MEMORANDUM

TO: ISC team
FROM: Daniel Sigg, Koji Arai
SUBJECT: EOM/AOM Diver Modifications
Refer to: LIGO-E1500353-v2

This modifications apply to [D0900761-B](#), [D0900847-B](#), [D0900848-C](#) and [D1000216-B](#) to bring them to revisions C, C, D and C, respectively.

Power Board [D0900848-C](#)

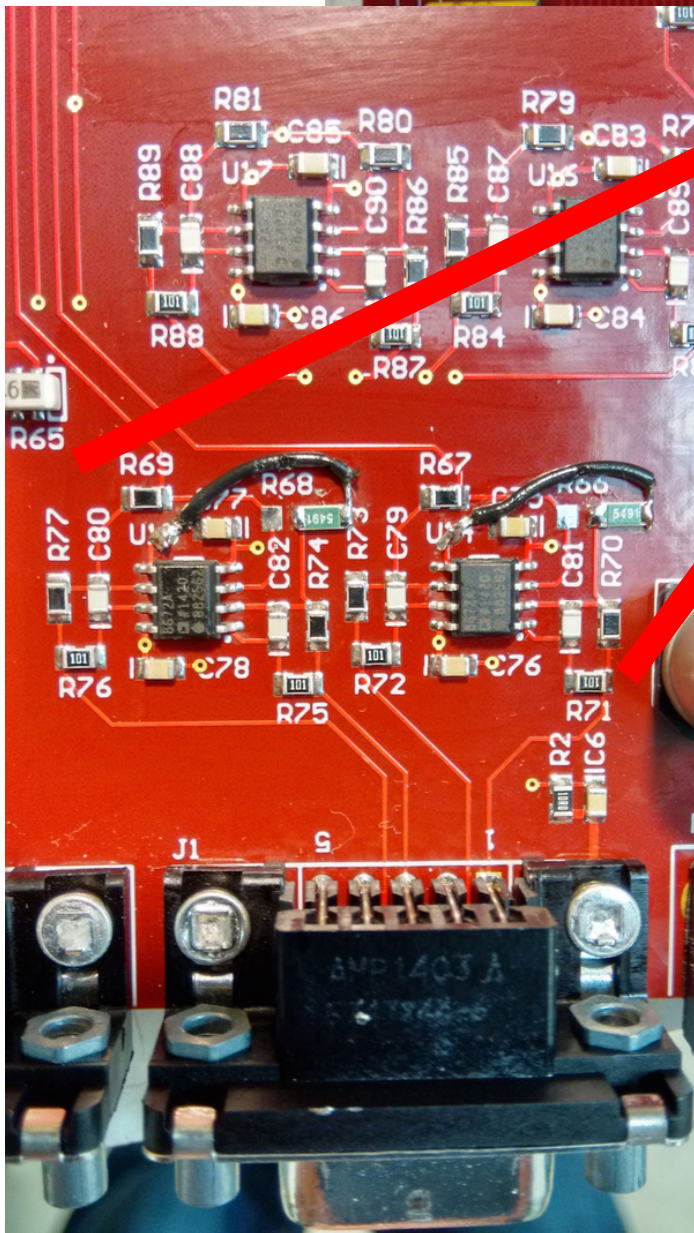
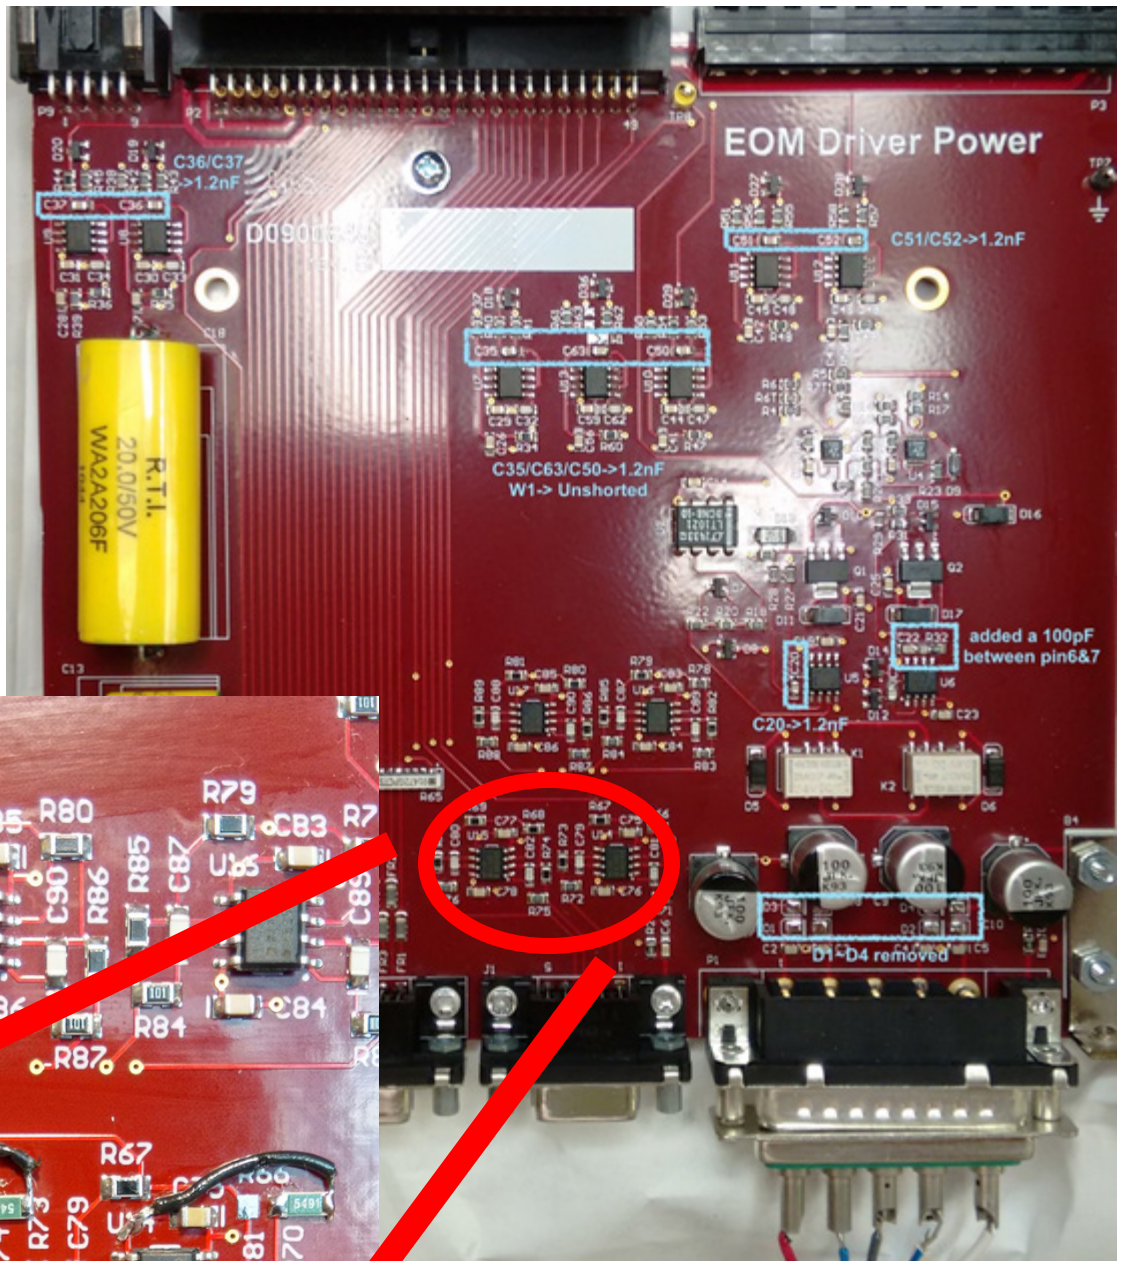
Fix the gain in the differential output stages.

R66, R68 → 5.49K, shift and use only the pad above R70 and R74

J1, J2 → add a jumper wire from the free end to ground (see pic)

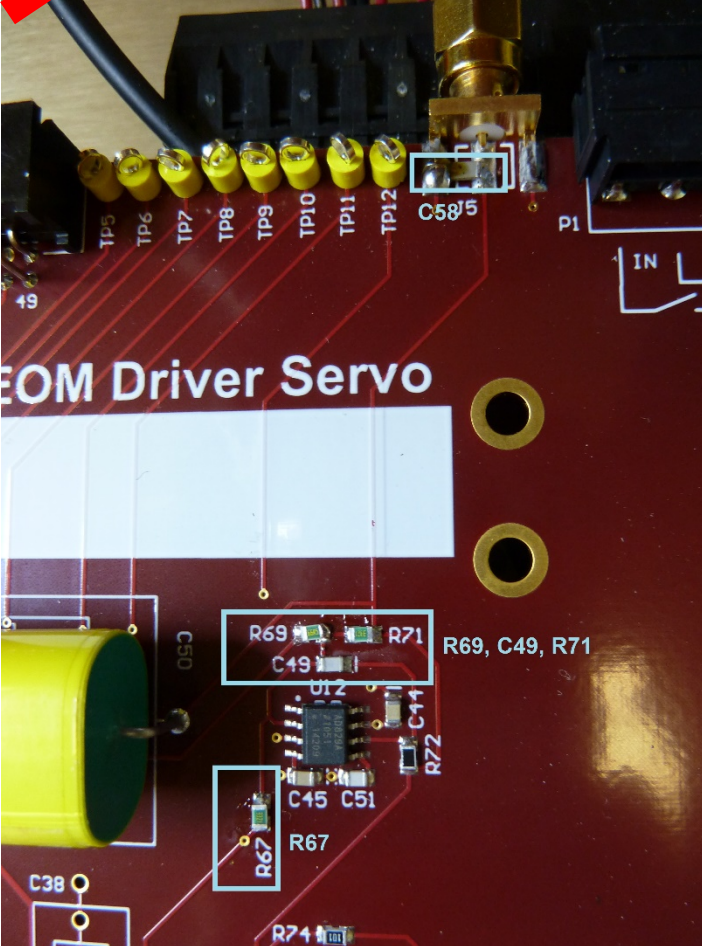
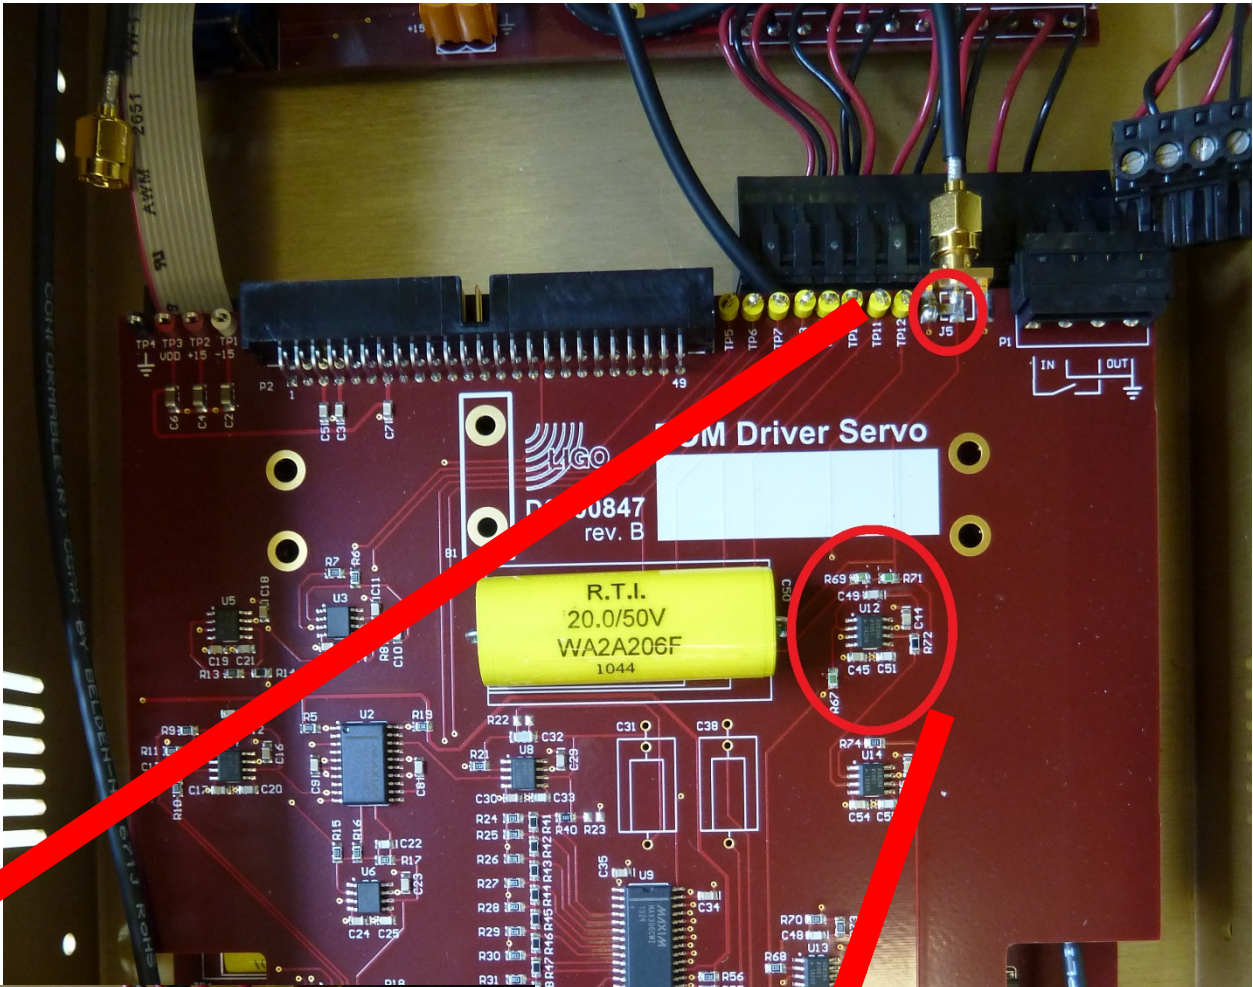
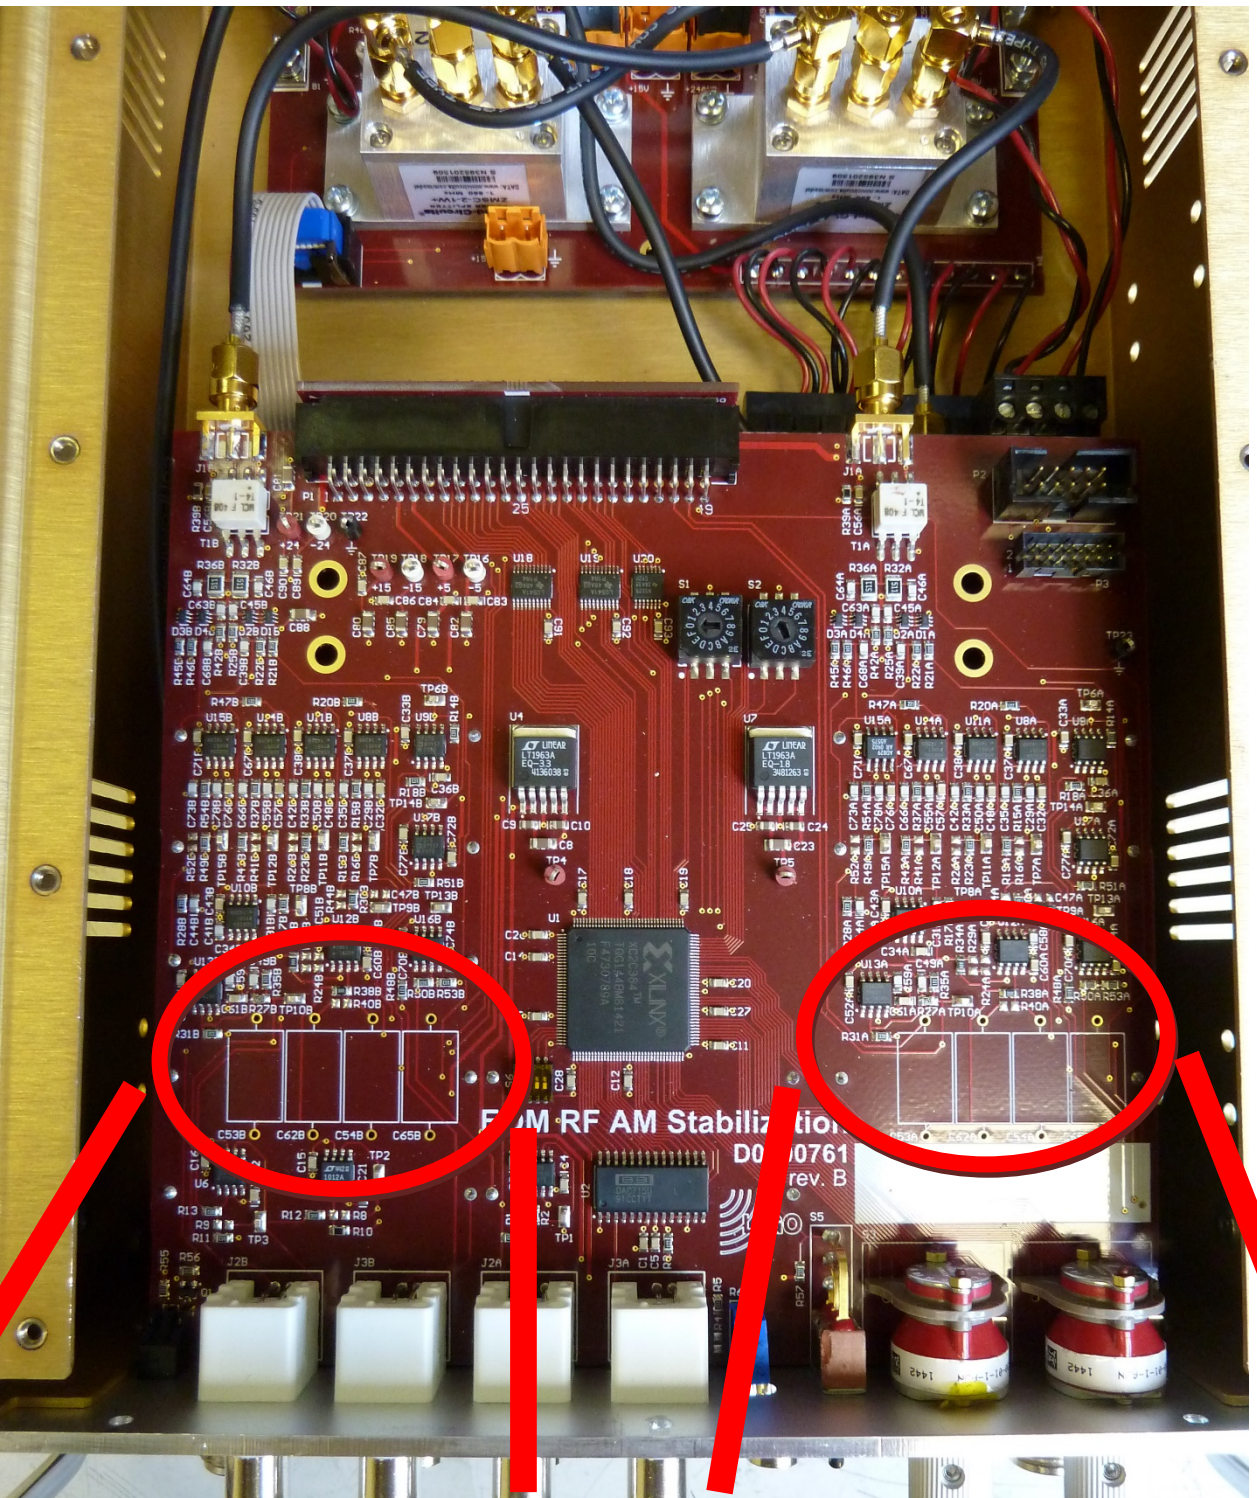
Check 1: Test the tabs of Q3 to Q9 on the power board for shorts with the rear panel.
(Powering up the chassis with a short will damage the transistor.)

Check 2: Make sure the backplane board is inserted center into the rear connectors.
(It is possible to offset the backplane by one row and damage Q1 or Q2 on the power board.)
